Field Change Note

FCN #: SKavach/ Jul-26/05

DISMANTLING AND RE ASSEMBLY OF RFID TAG'S TURN-OUT POINT FRP

Field Change Note for RFID TAG Assemblies for Turnout Tags 290726

Fig-3

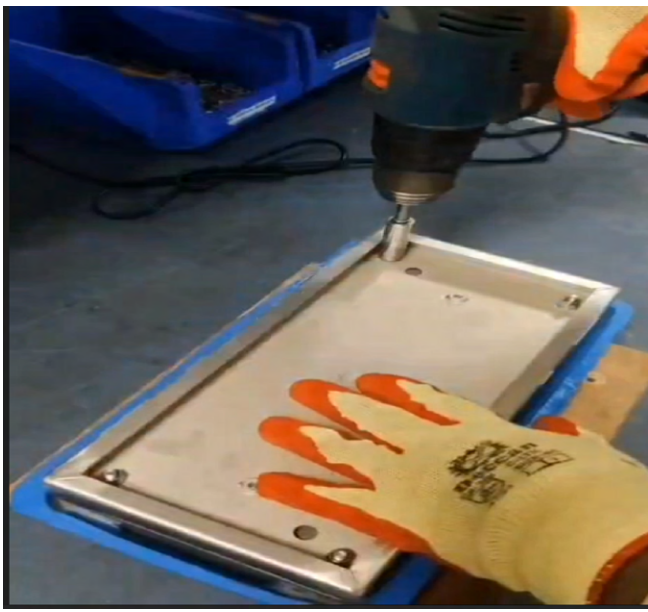
Step-3: Use Top cover FRP Mould for removing the bottom cover as shown in fig-3

Fig-4

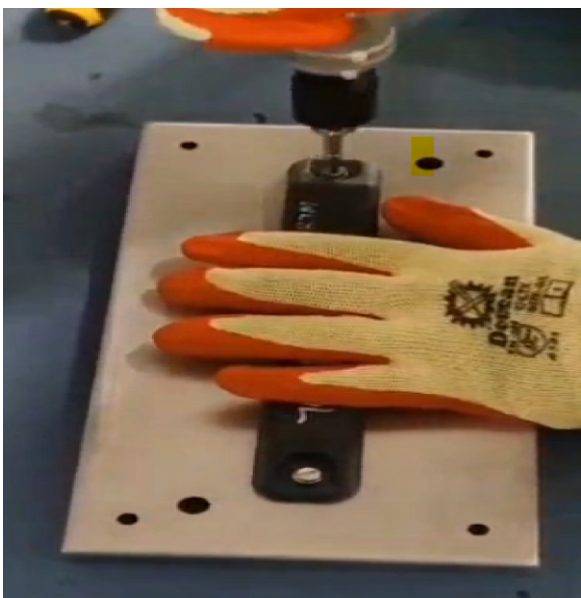
Step-4: Remove the TOP FRP cover by using mould jig by unscrewing the M6 nylock nut's as shown in fig-4
